**CONDITIONAL APPROVAL**  
**PLAN APPROVAL EXPIRES: 08/05/2017**

Melrose - Mindoro Schools  
N181 State Hwy 108  
Town of Melrose, 54642  
Jackson County; Fire Dept ID: 2706  
NW1/4, SE1/4, S31, T19N, R5W

Tenant Name or Addn/Alt Description: High School Tech Education  
Plan Type: Addition-Alteration; 1 Interior  
Fixture(s)

Tenant Name or Addn/Alt Description: High School Tech Education  
Object Type: Commercial Water Treatment Device Regulated Object ID No.: 1550099

## General Floor Plan

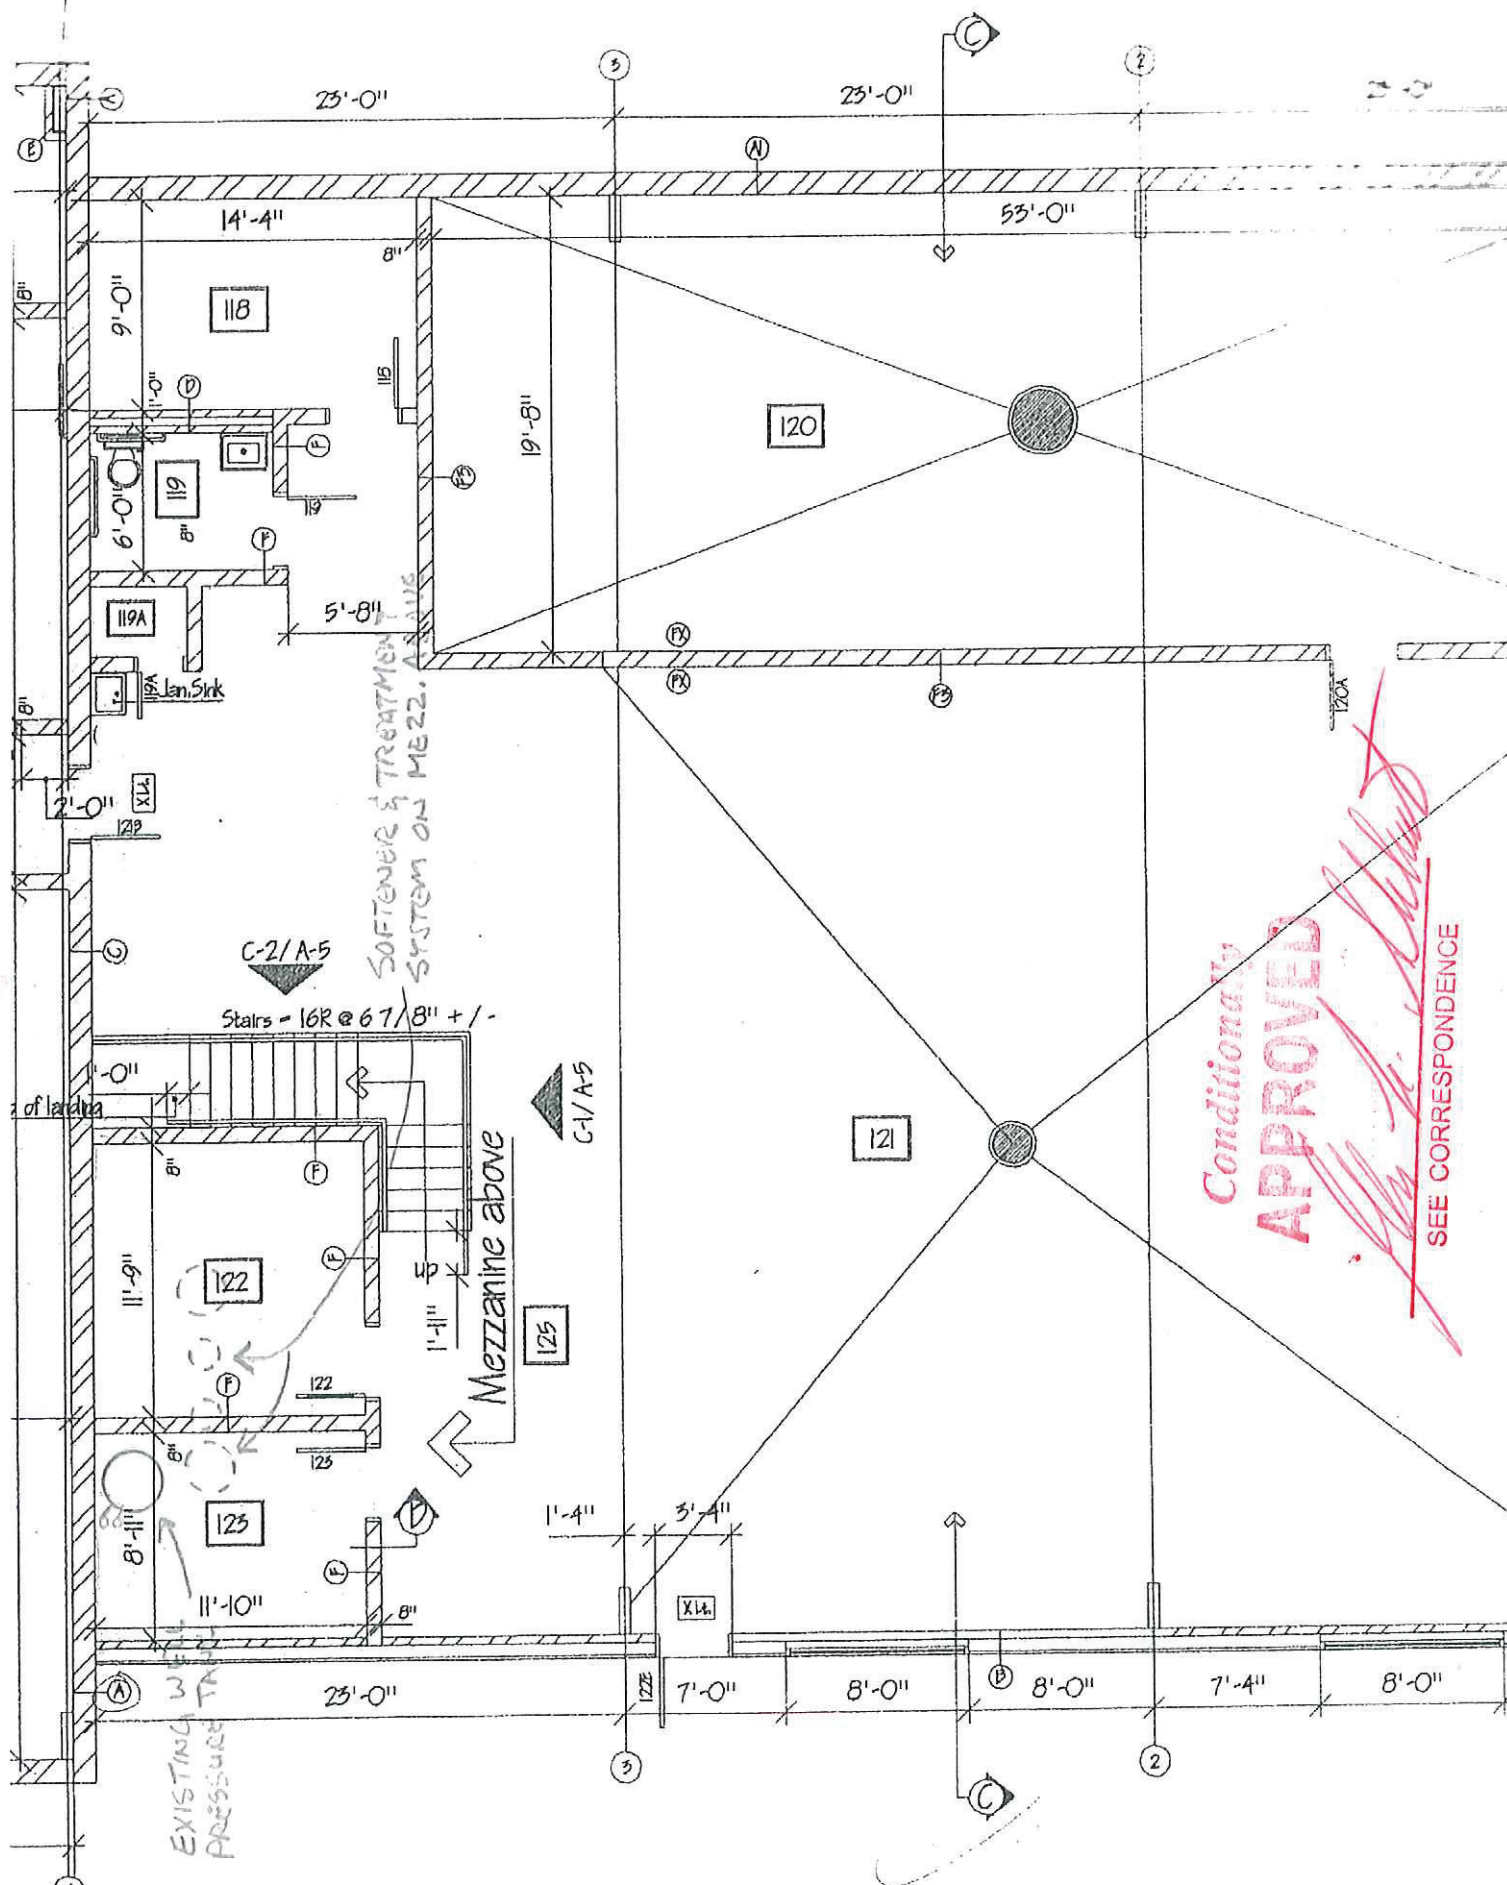
*Conditionally*  
**APPROVED**

SEE CORRESPONDENCE

SEE CORRESPONDENCE

### 3. Isometric Drawing

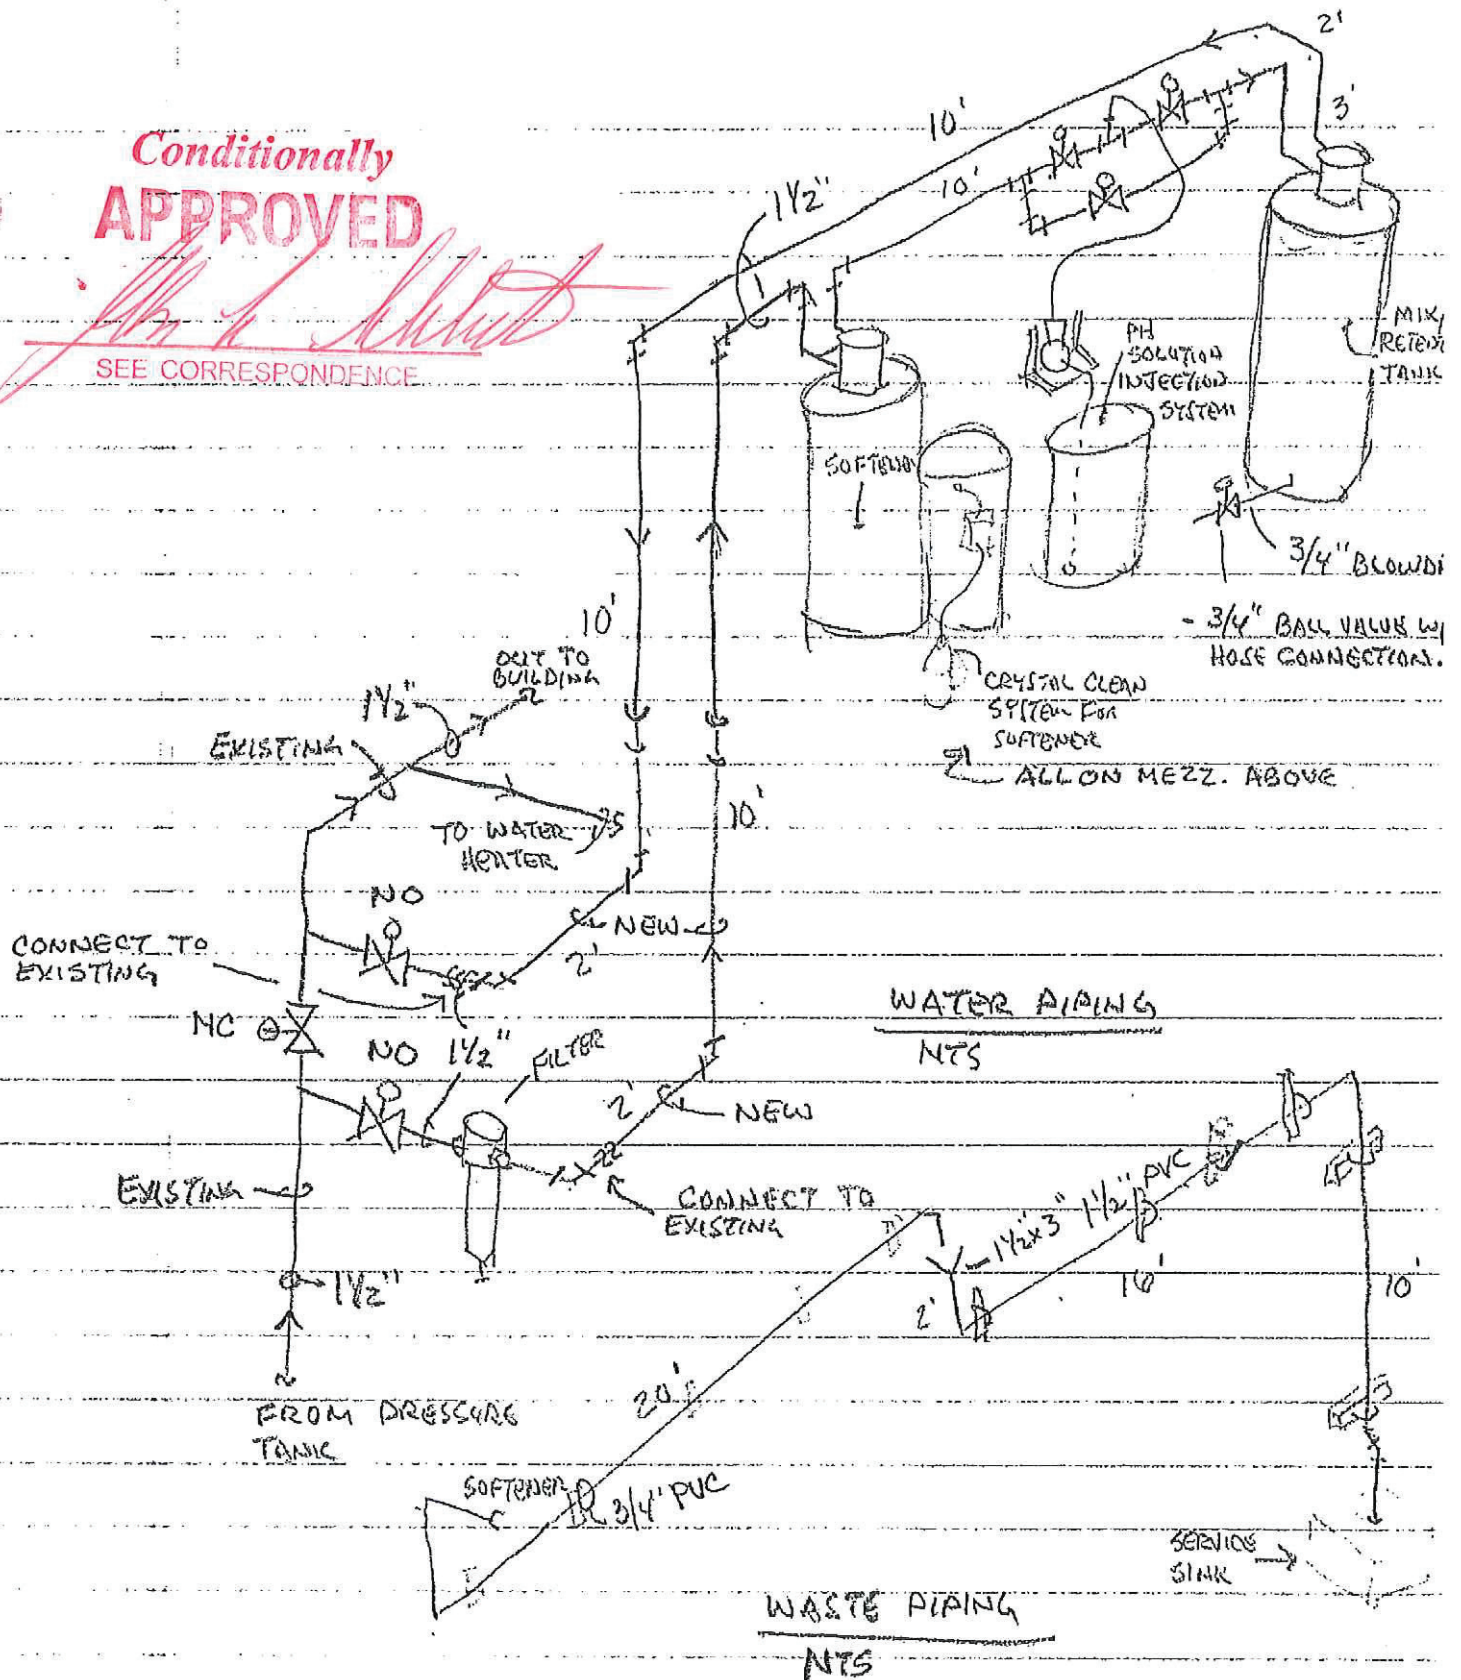
**Conditionally  
APPROVED**

SEE CORRESPONDENCE
